CITY OF LOS ANGELES
INTER-DEPARTMENTAL CORRESPONDENCE

5600 W Hollywood Bl
DOT Case No. CEN20-49816

Subject: **TRANSPORTATION ASSESSMENT FOR THE PROPOSED RESIDENTIAL PROJECT LOCATED AT 5600 HOLLYWOOD BOULEVARD (CPC-2020-4296-CU-DB-SPP-SPRVHCA-PHP/ENV-2020-4297-EAF/PAR-2020-3499-VHCA)**

PROJECT SITE PLAN

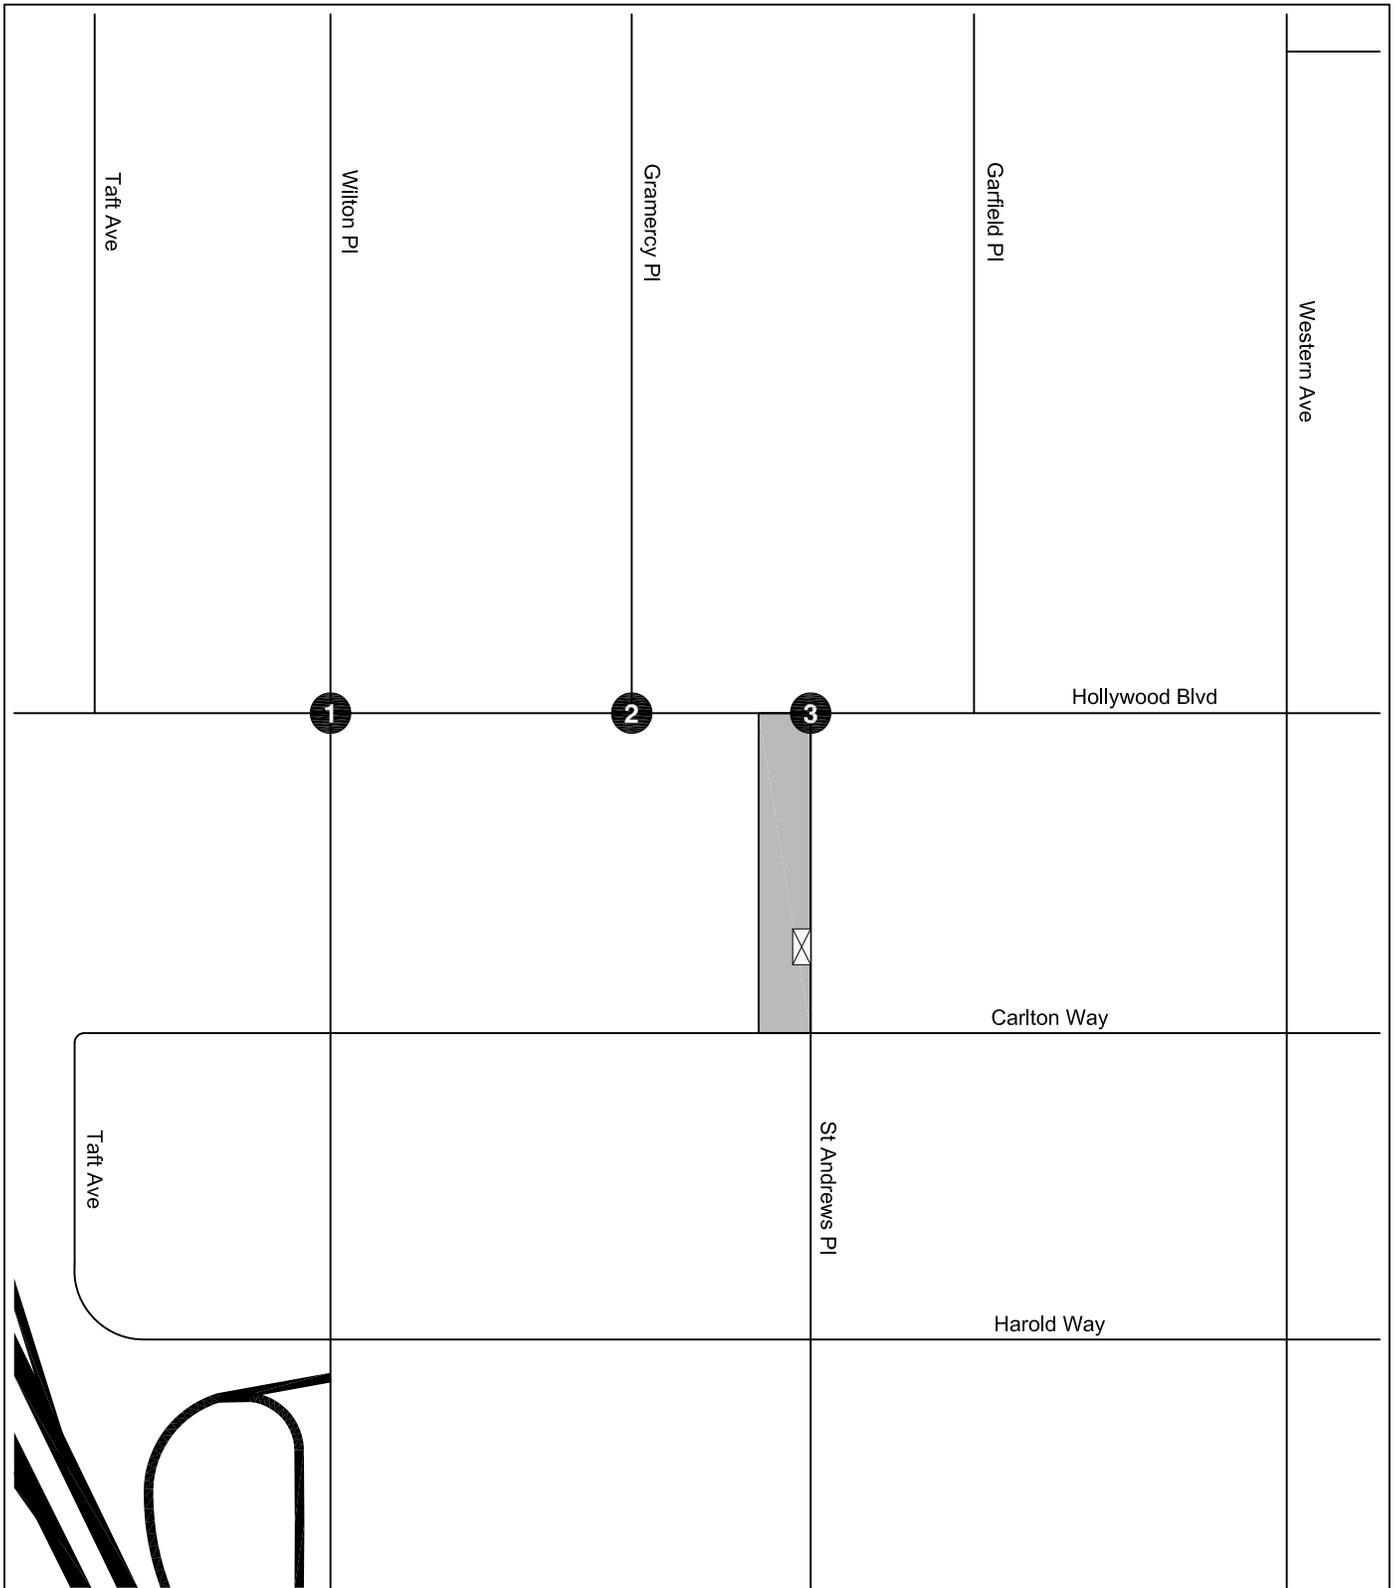
The conceptual site plan for the project (see **Attachment A**) is acceptable to DOT. Access to the project will be provided via one driveway along St. Andrews Place. Review of this study does not constitute approval of the dimensions for any new proposed driveway. Review and approval of the driveways should be coordinated with DOT's Citywide Planning Coordination Section (201 North Figueroa Street, 5th Floor, Room 550, at 213-482-7024). In order to minimize and prevent last minute building design changes, the applicant should contact DOT for driveway width and internal circulation requirements prior to the commencement of building or parking layout design. Driveway placement and design shall be approved by the Department of City Planning (City Planning) in consultation with DOT, prior to issuance of a Letter of Determination by City Planning.
